PLANNING COMMITTEE MEETING – 4TH MARCH 2015

Amendment/De-brief Sheet

Shadow / Sunlight
Analysis at Broad Street - June 21st 1600 - 1700 - 1730

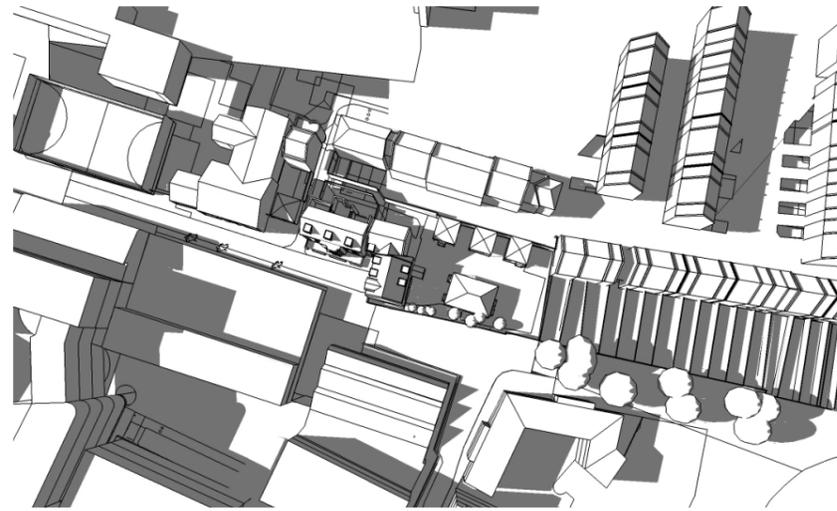
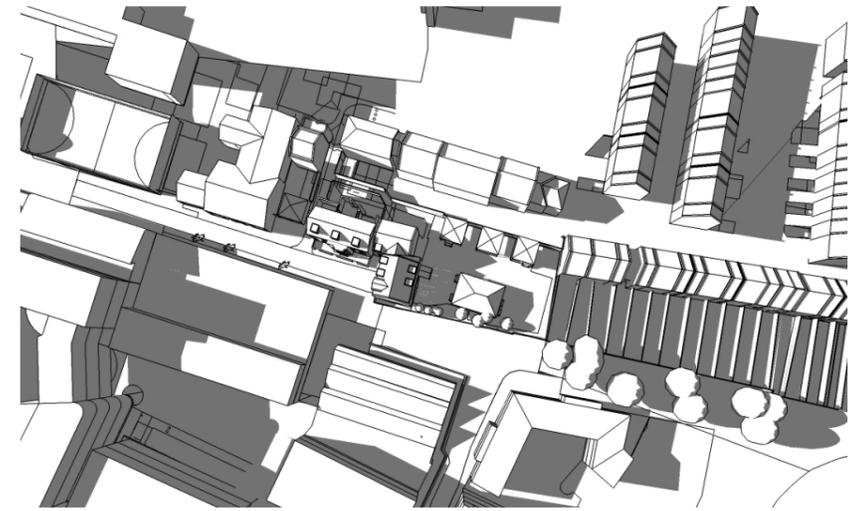
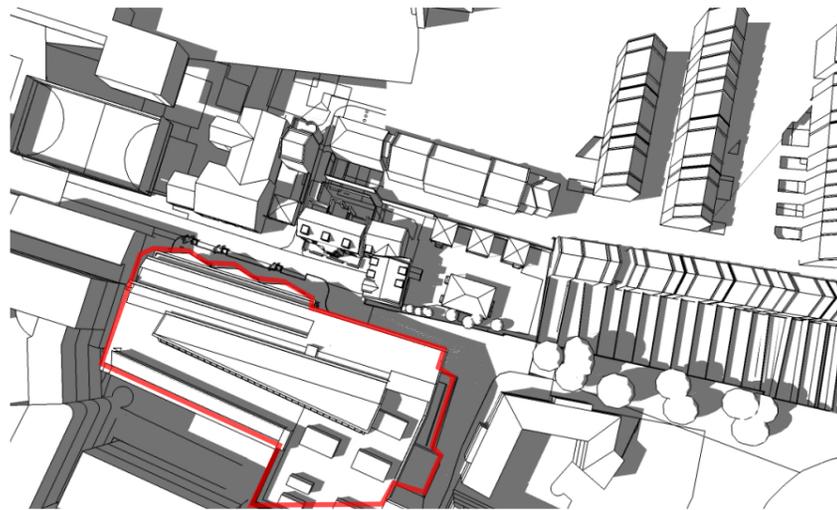
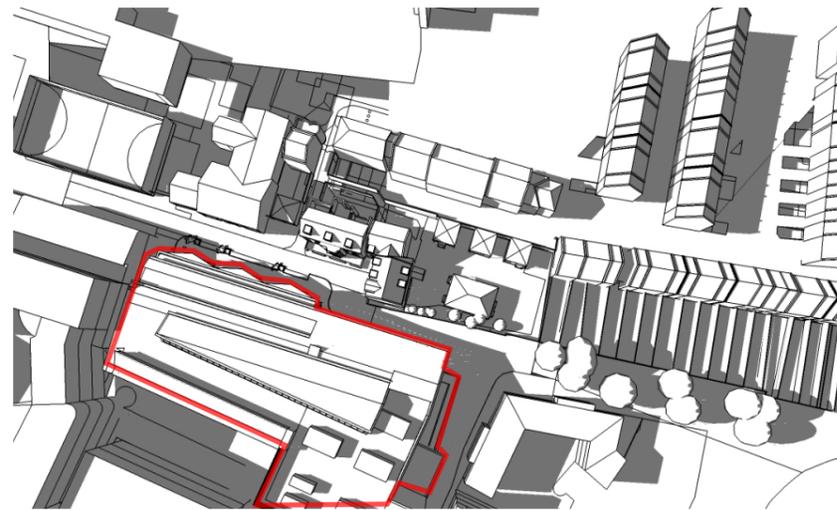
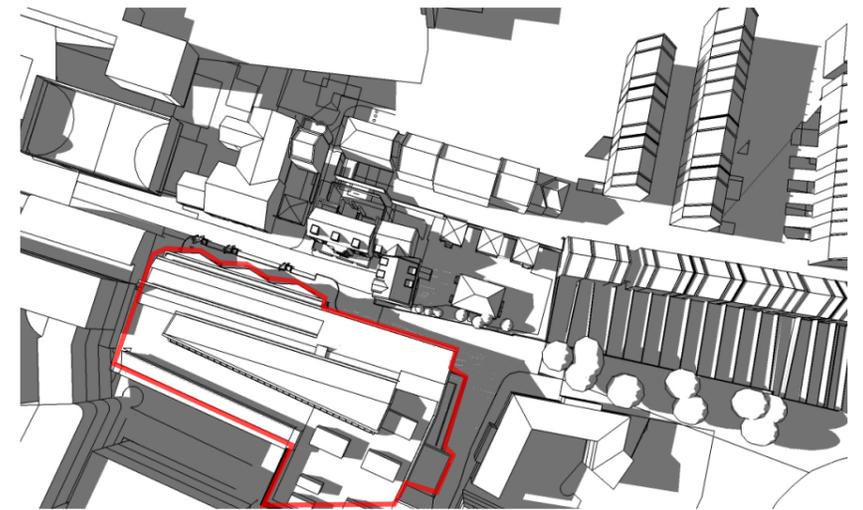
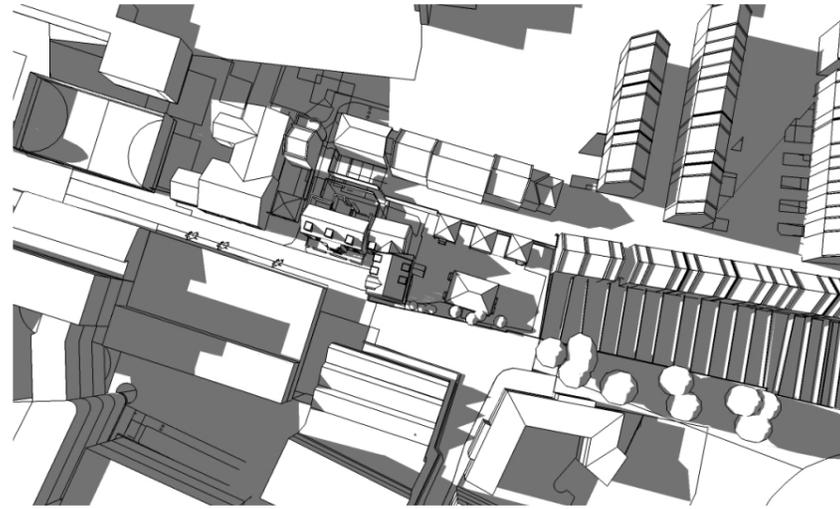
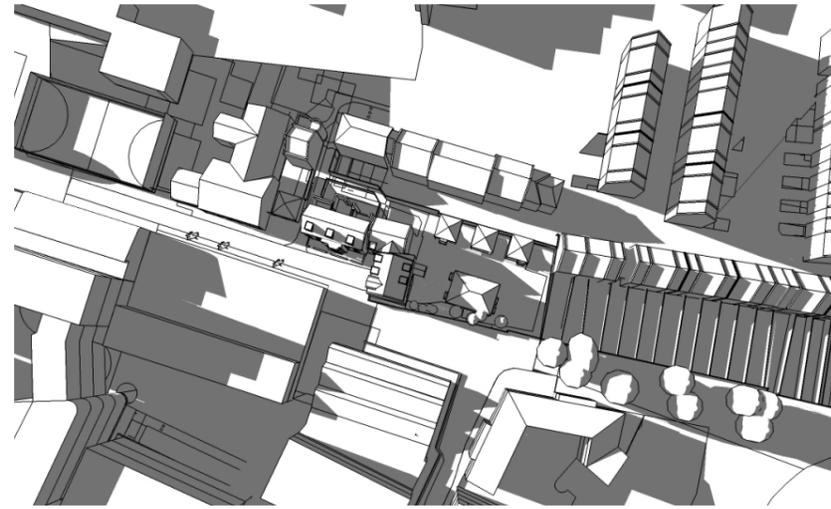
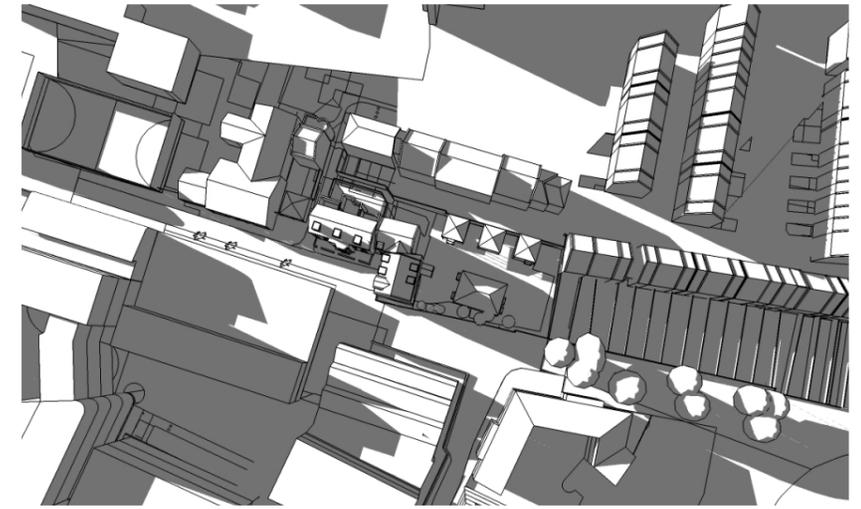
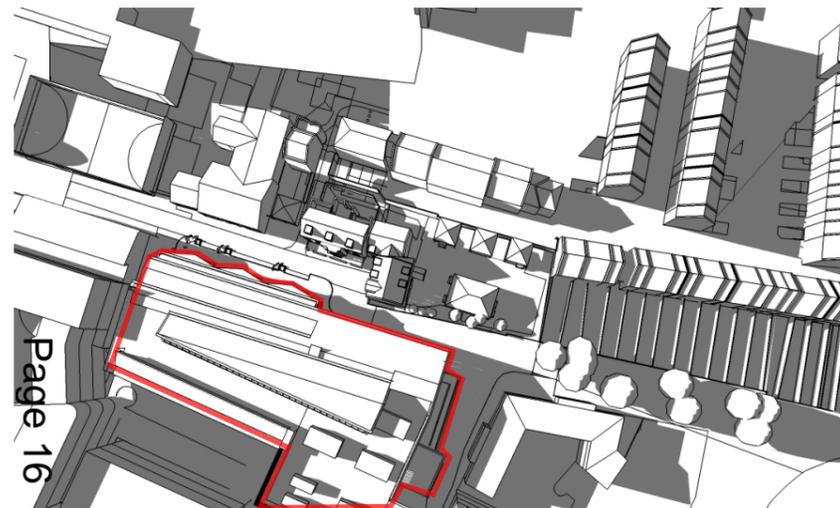
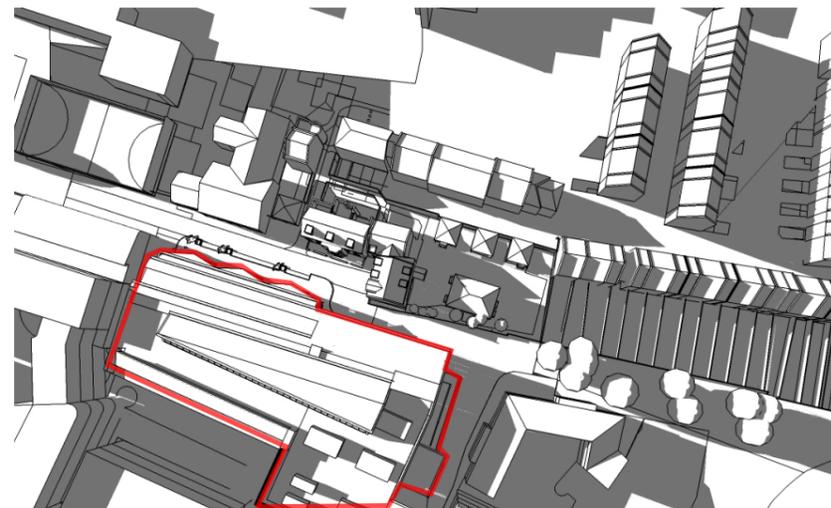
- The proposal is still too big and bulky in relation to Norfolk Terrace;
- Disruption and reduced access to our residential area (Broad Street);

- Noise pollution during construction;
- Reduction in light to our property and reduction in value to our properties;
- Increase in mice and other vermin;
- Plumbing problems and increase in dust and dirt;
- Over-looking;
- Lack of aesthetics/out of character with the Victorian homes.

In response to the comments made by neighbours about loss of light, the agent has submitted a further shadow diagram showing the impact at the June 21st Equinox at 4pm, 5pm, 5.30pm, 6pm, 6.30pm and 7pm. I attach a copy for information purposes. The shadow study demonstrates that during the peak of the equinox period, the impact on neighbouring properties is minimal and not significant to warrant refusal, in my view.

TITLE:
 Swept Path Analysis of
 Site Plan
 Emergency Vehicles

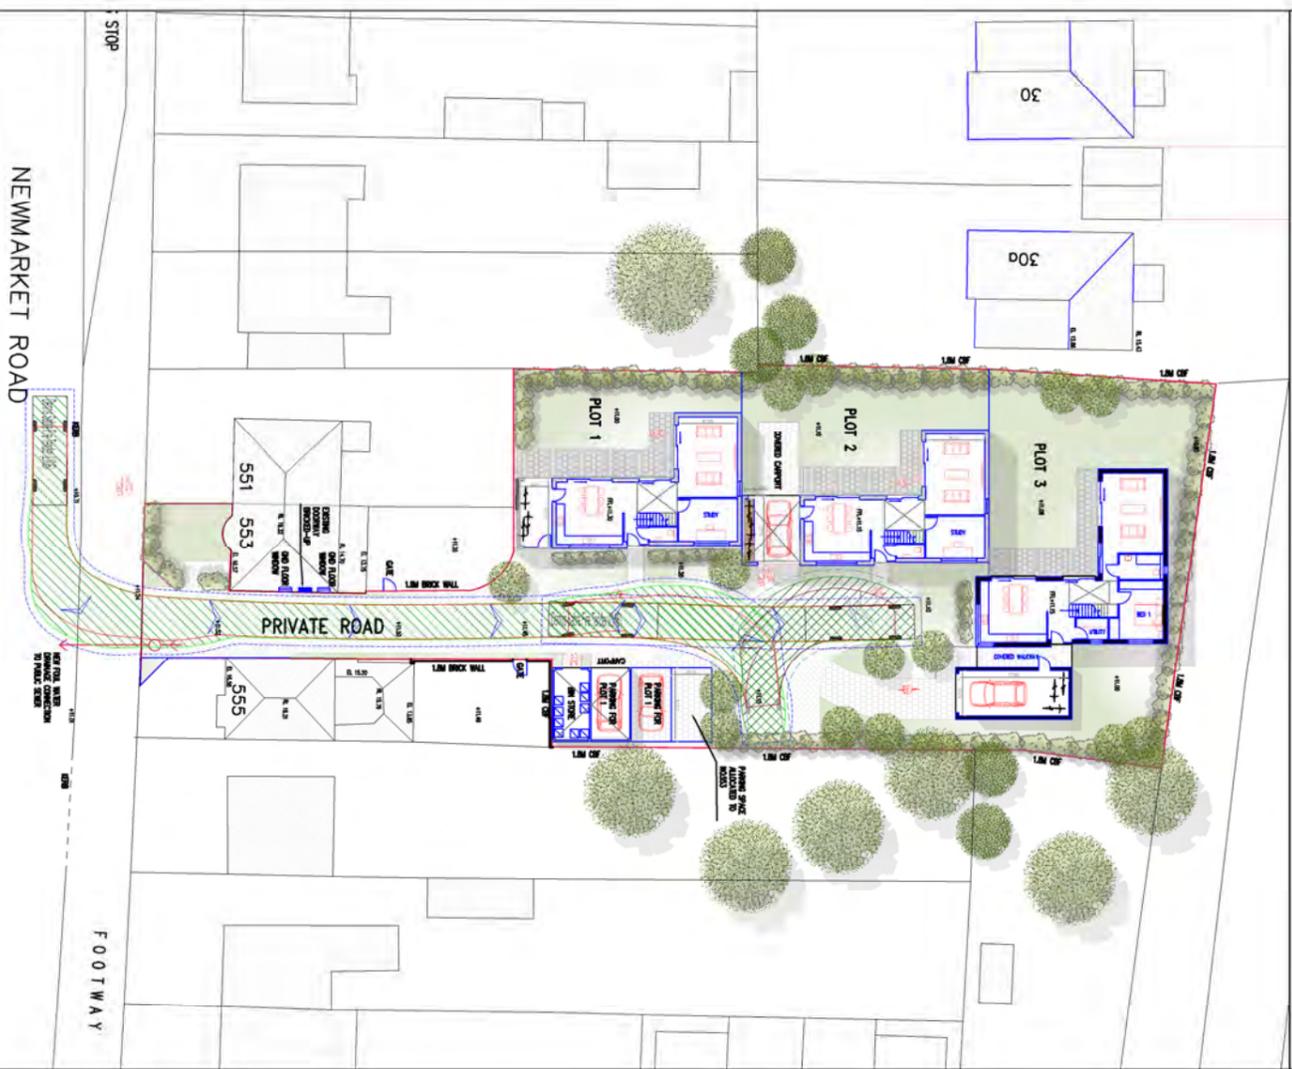
- 1.5 The plan at **Appendix A** shows the proposed layout of the development.
- 1.6 Application 14/1653/FUL has been submitted and was taken to planning committee. It is understood that specific issues were raised by committee members in relation to the site's access arrangements. This Technical Note has therefore been provided to address those questions raised, namely:

- 2.4 Swept path analysis has also been carried out to ensure that a fire tender and an ambulance may safely access all of the dwellings at the site.
- 2.5 The associated drawing is provided at **Appendix C** and it demonstrates that both vehicles may turn in the site, ensuring access and egress in forward gear.
- 2.6 The fire tender is the largest of the emergency vehicles therefore the fact that this can access all dwellings satisfactory means that the development will be fully accessible by all emergency vehicles.
